**MEETING AGENDA  
CITY OF BANDON PLANNING COMMISSION  
THURSDAY, JULY 25<sup>TH</sup>, 2024 - 7:00 P.M**

**SUBJECT:** **5.1 24-007, A REQUEST FOR APPROVAL OF A CONDITIONAL USE PERMIT TO REMODEL AND ENLARGE AN EXISTING CHURCH (HOLY TRINITY CATHOLIC CHURCH) AT 355 OREGON AVE SE IN THE CITY OF BANDON.**

Re: Holy Trinity Church Building - Conditional Use Permit,  
Application File Name (#): 24-007

**1 SITE PLAN - ELECTRICAL**

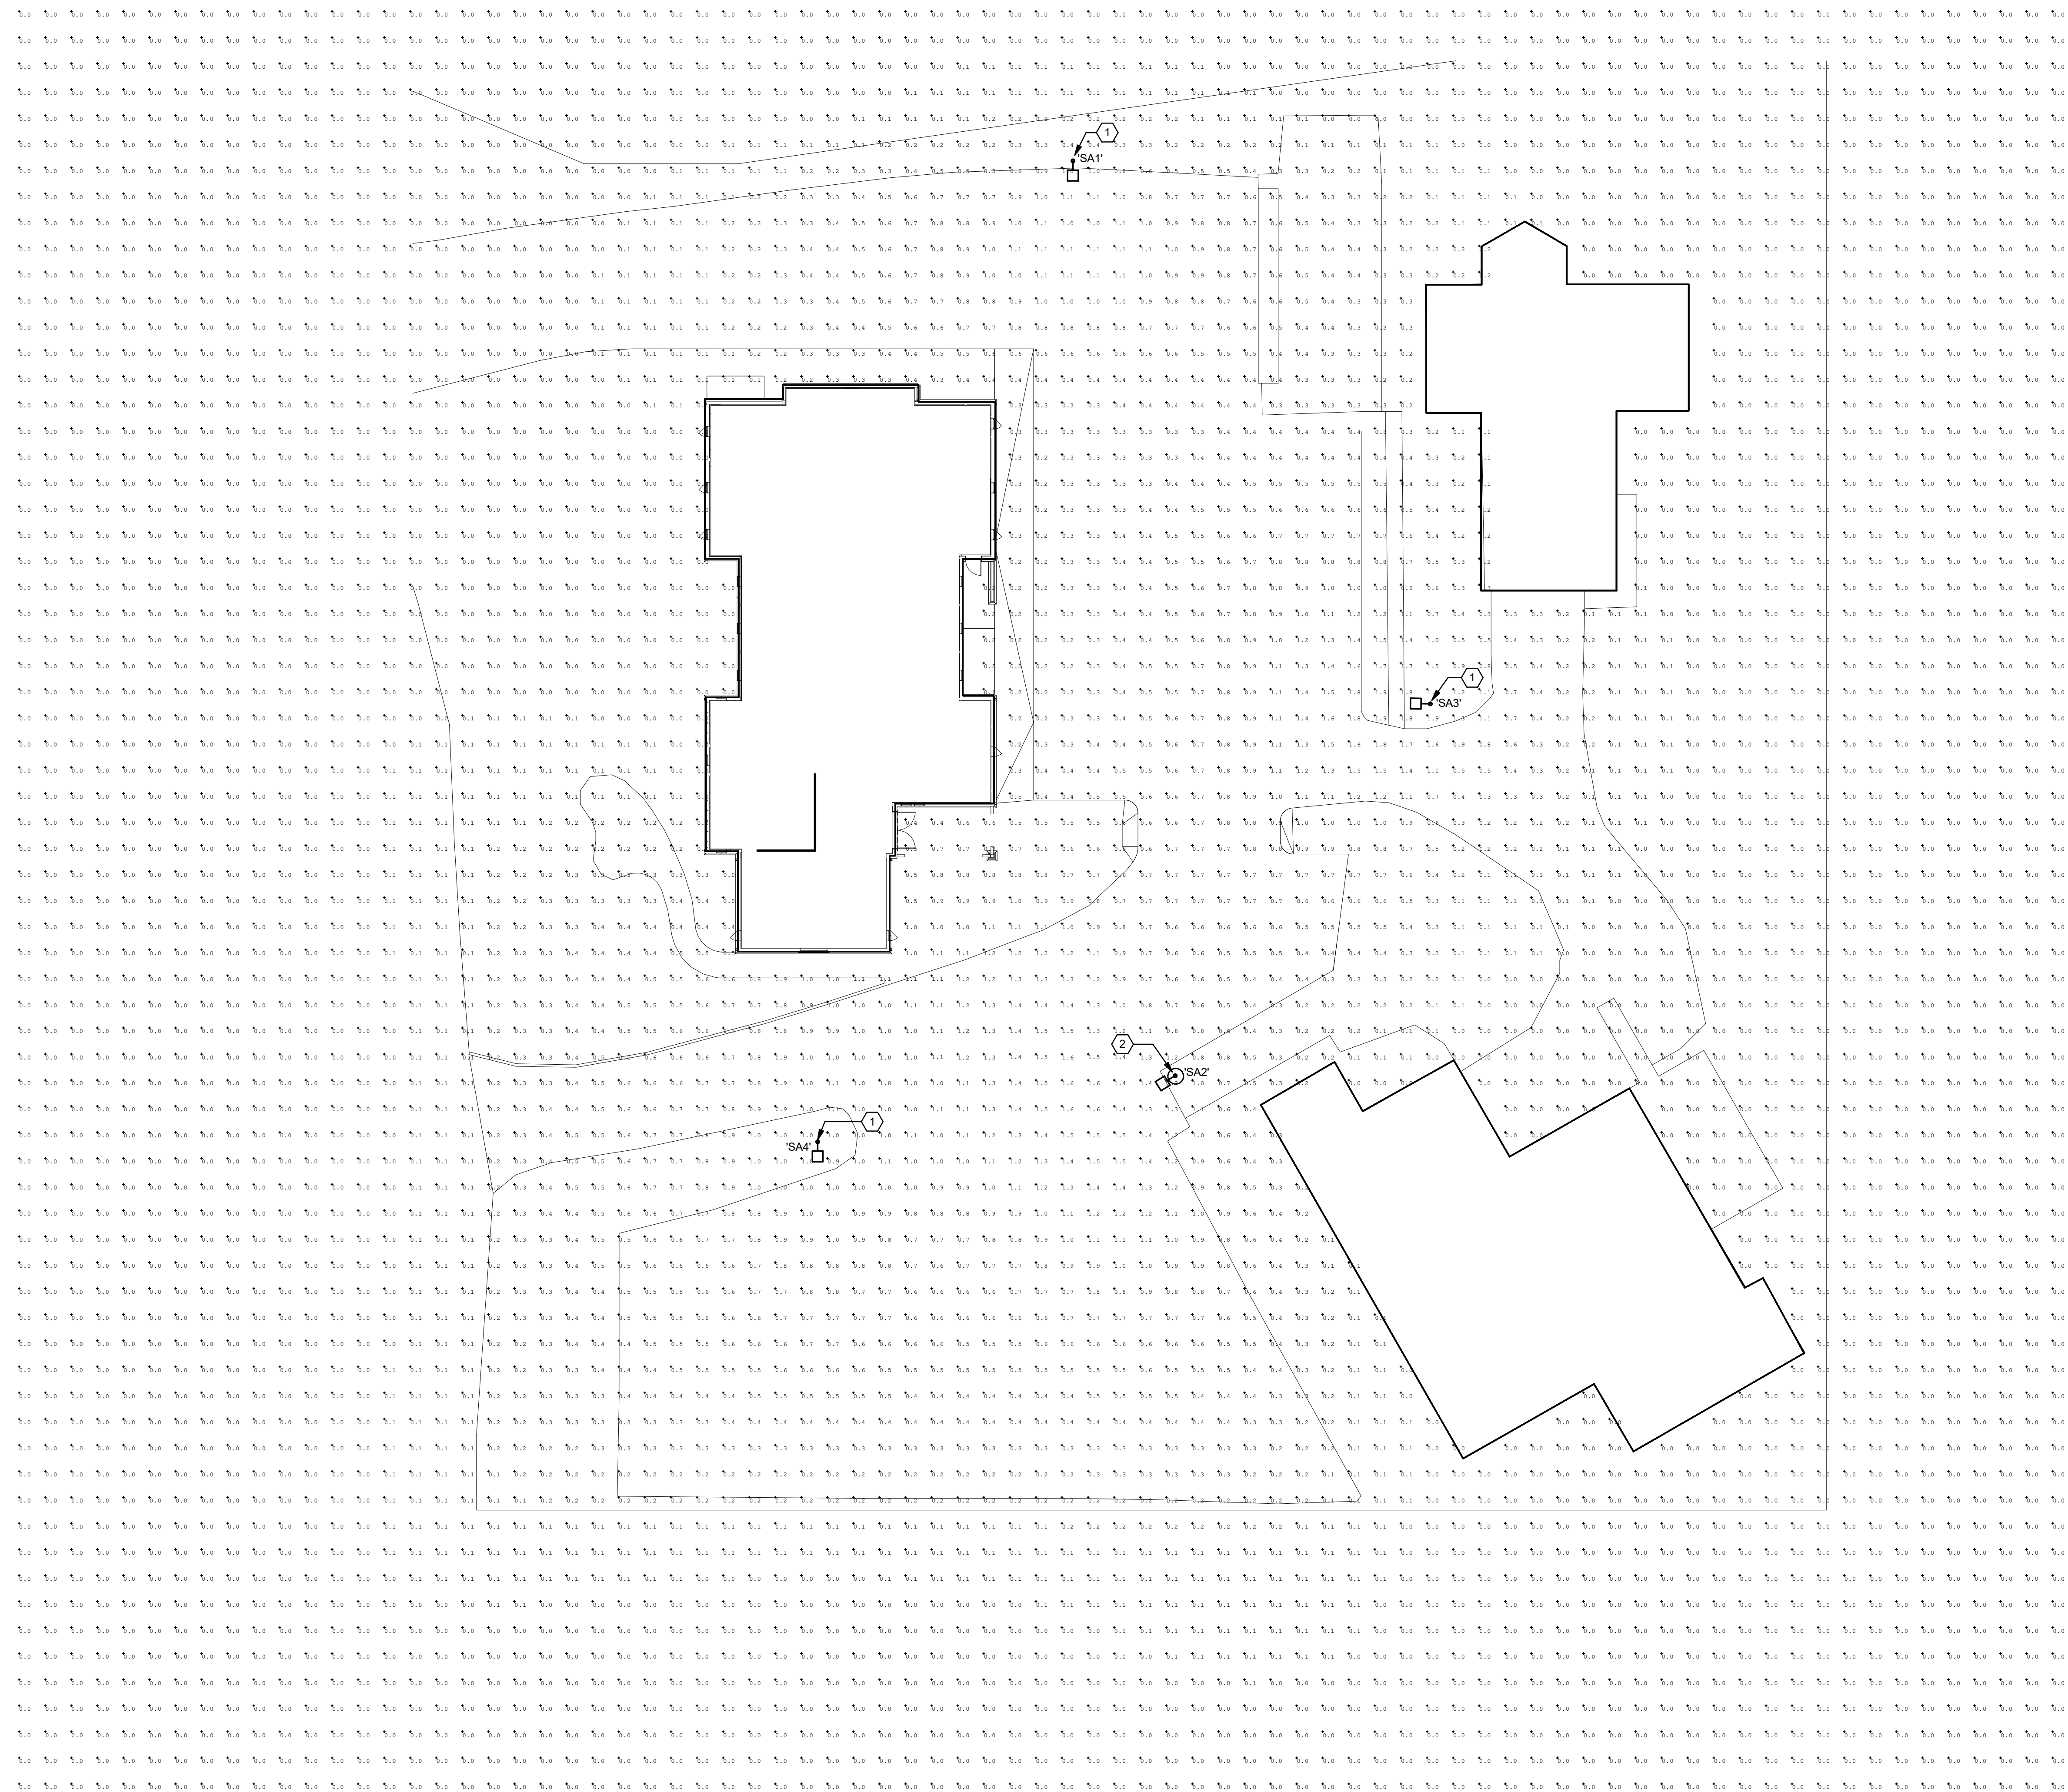
11. PROVIDE NEW 2" C. BELOW GRADE FROM TELECOM UTILITY PEDESTAL TO NEW WALL-MOUNTED RACK LOCATION IN BUILDING.
12. EXISTING SITE LIGHTING POLE TO REMAIN. (2) EXISTING AREA LUMINAIRES AND BULLHORN SUPPORT TO BE REMOVED FROM TOP OF POLE FOR REPLACEMENT WITH SINGLE, NEW AREA LUMINAIRE.
